project: General Interior Renovations of 250 College
St. Ground, 8, 9, 10, & 11th floors ADD # 01

CAMH RFP # 1175.23 date: 2023-08-30
HJA proj no: 22-48

This addendum forms part of the contract documents and is to be read, interpreted, and co-ordinated with all other parts. The cost of all contained herein is to be included in the stipulated bid price. The following revisions supersede the information contained in the original drawings and specifications issued for the above-named project to the extent referenced and shall become part thereof. Acknowledge receipt of this Addendum by inserting its number on the tender form. Failure to do so may subject bidder to disqualification.

01 8TH FLOOR
A-501 3/32" = 1'-0"

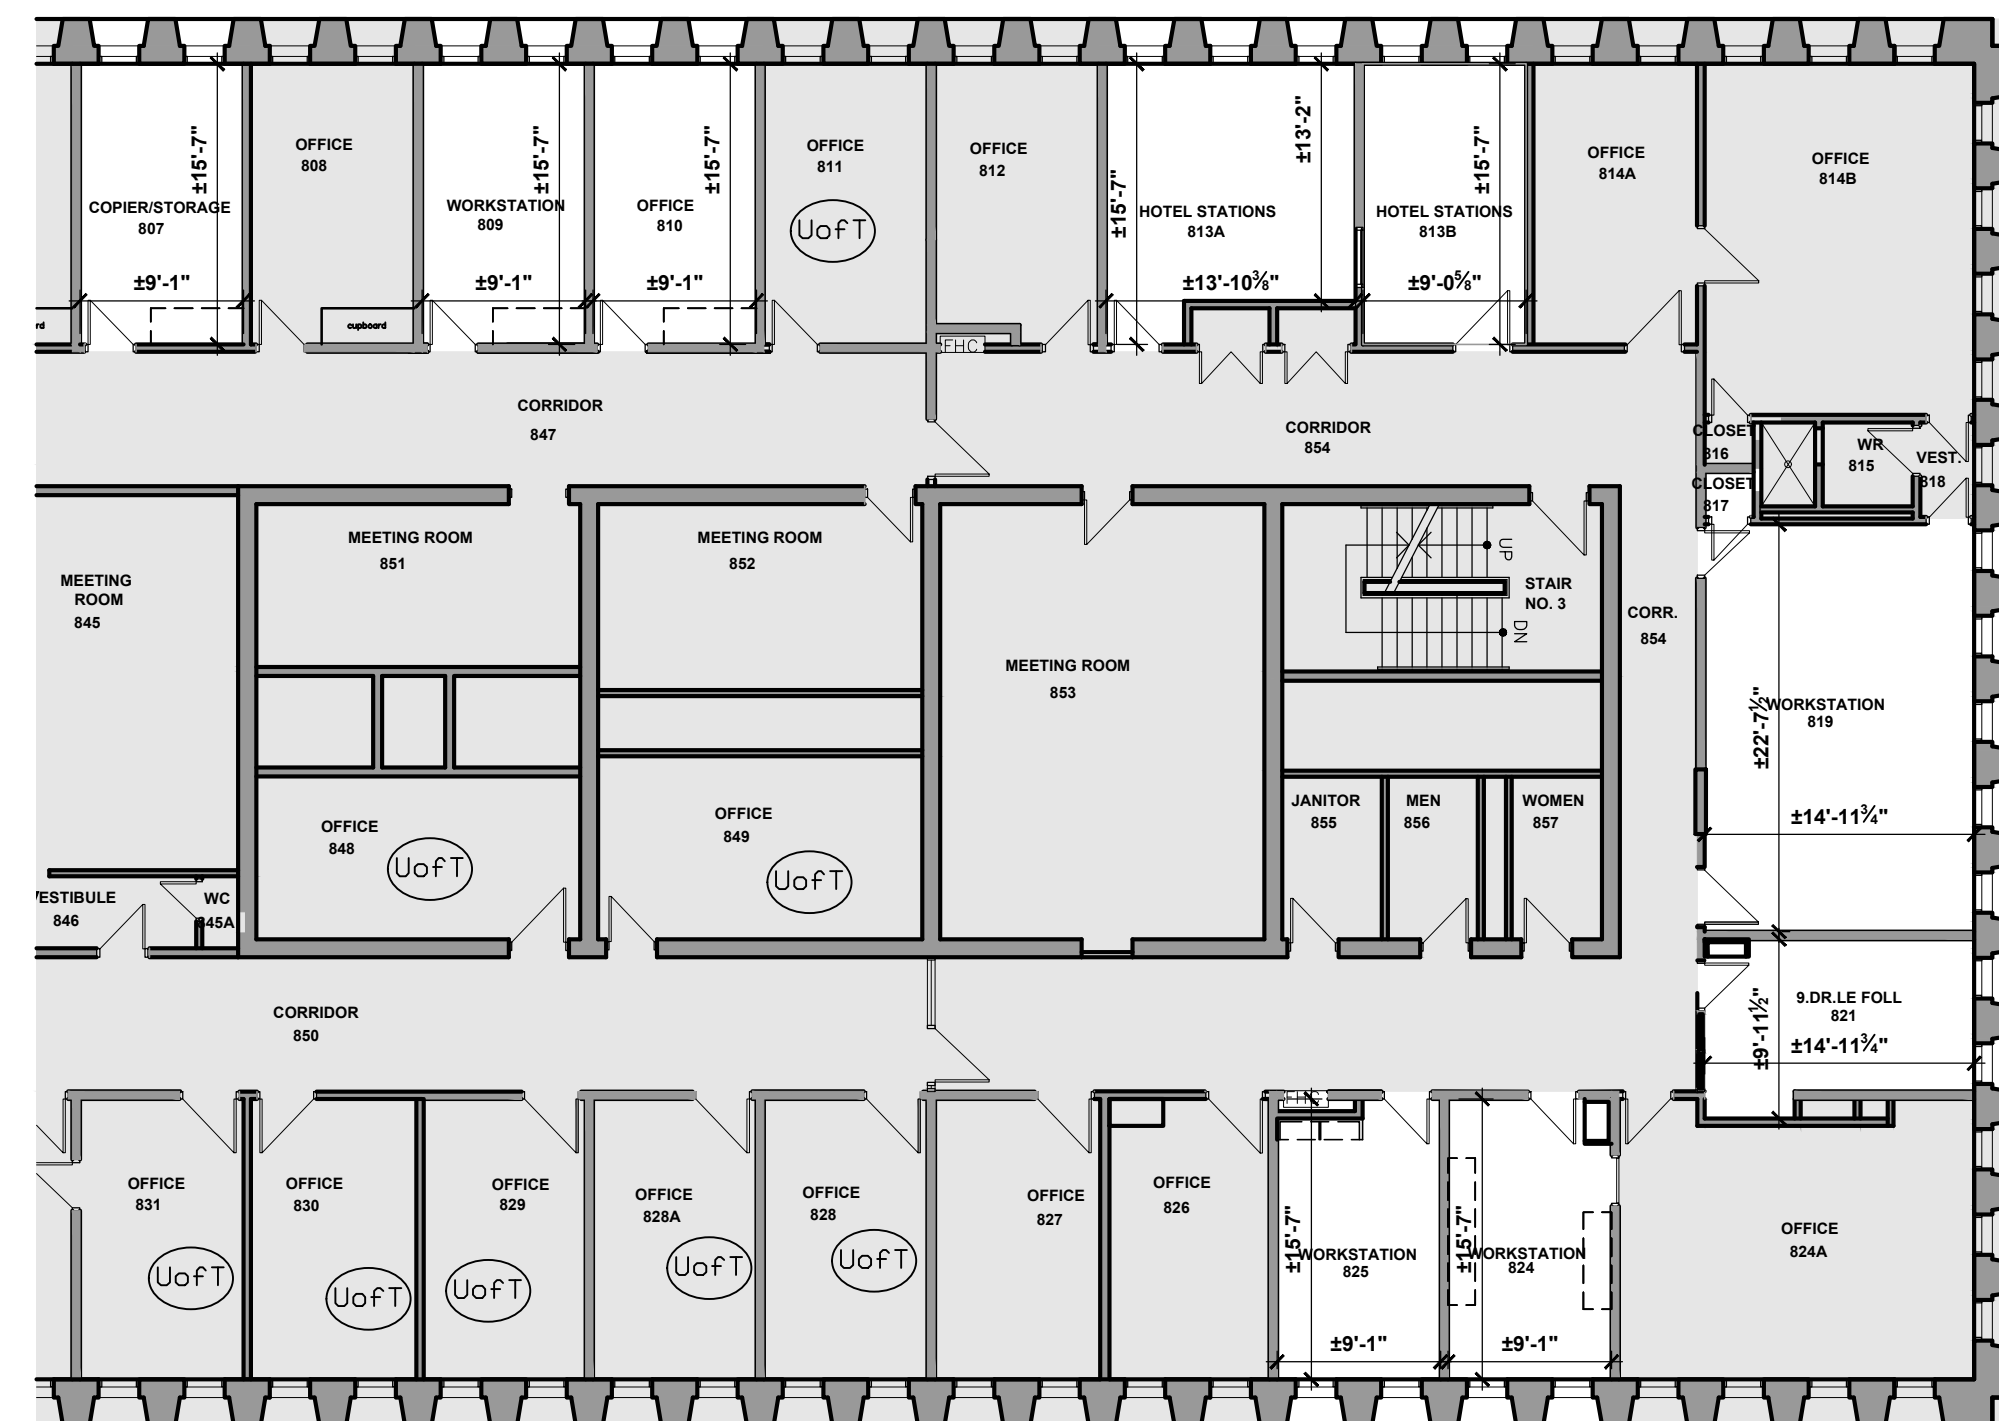
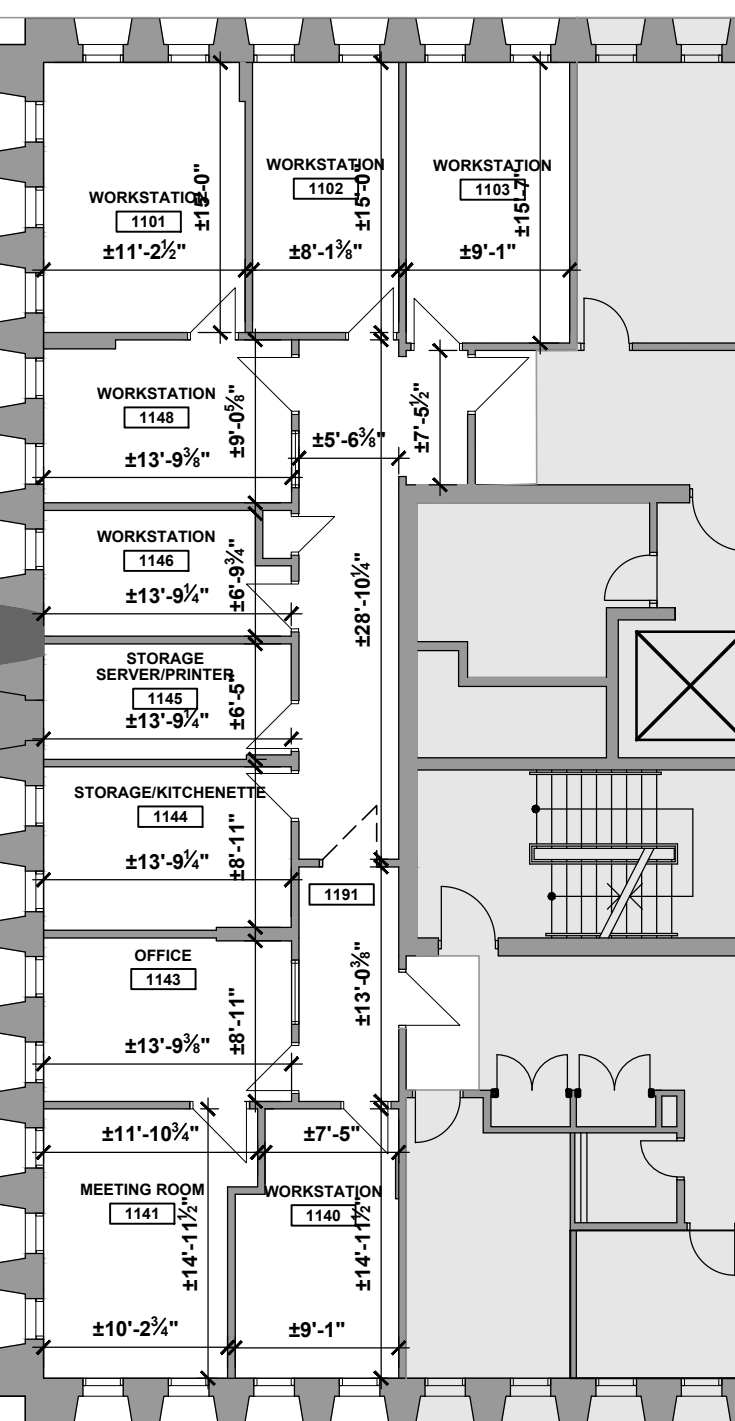
If the Consultants will not provide dimensions and the Owner is prepared to assume the risk associated with having Bidders determining the actual extent of the requirements please allocate no less than 5 business days for Bidders, with their selected Subcontractors and Suppliers, to have uninterrupted and free access to all areas subject to the proposed renovations so to measure each

room, space and corridor to complete the dimensioning requirements; this would allow Bidders a business day per floor plus an additional day for follow-up / supplemental review, to document all required measurements. Given the current indication of the initial date for the Mandatory Site Visit and the time requirement for Bidders to accumulate the required information please then allow the Bidders 2 business days to tabulate and distribute the supplemented Bid Documents and maintained the currently allowed 5 business days for Bidders to collect, tabulate and populate your RFI Form for submission through this portal. As such please revise Item 3.1.1 Timetable of the RFP to allocate the 5 business days for site review and measuring, 2 business days for tabulation and distribution of supplemental Bid Information, and 5 business days for review and assembly of questions into your RFI Form resulting in need for further revision to the date for final addenda and Bid Closing. Alternatively, please have the Consultants provide the missing information, specifically dimensions of all spaces, including provision of vertical dimensions including floor to floor heights, and the re-issue the updated and complete Bid Documents.

Response: Drawings A-500 and A-501 dated Aug 28, 2023 are issued with this addendum. These drawings provide overall approximate dimensions and areas of the areas of work. These drawings are issued for the express purpose to enable bidders to perform approximate takeoffs to provide work and materials requested. Verification of actual as-built site dimensions for all aspects of the work will be the responsibility of the successful bidder.
